Daimler Trucks

North America LLC Customer Advisory Letter

Subject : Proactive Sam Chassis Replacement

Models Affected: 37 2015 Cascadias for [REDACTED]

Fig. 1, SAM Chassis with a Drip Shield and a Drip Loop

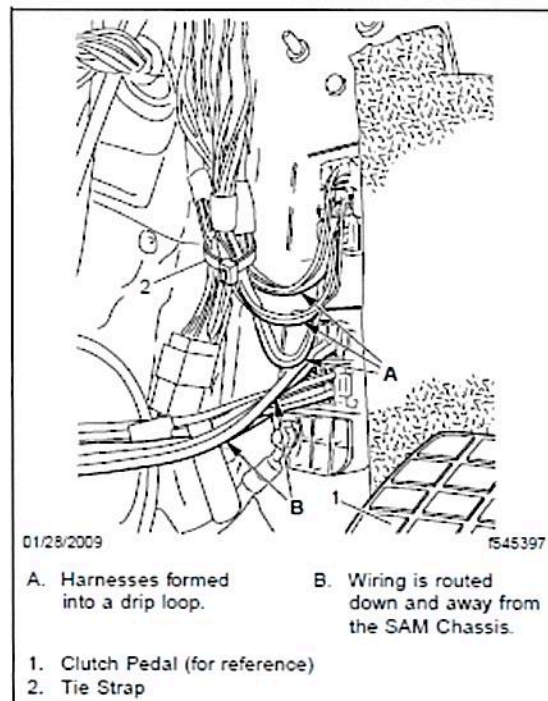
1. Replace Sam Chassis Module Refer to Workshop manual section 54.02 subject 100. **Save all old modules**
2. Install new Sam Chassis cover as instructed in SB 54-294
3. Install A22-68255-000 drip shield on front wall See figure 1 part marked #1
4. Insure drip loop in harness See figure 1 & 2 circled "A"
5. Replace fuses in the Sam Chassis with PDC's

Make sure that the drip shield is in contact with the frontwall at all points. If there is no drip shield installed or the drip shield is loose or separated at any point from the frontwall, replace the drip shield ordering part A22-68255-000.
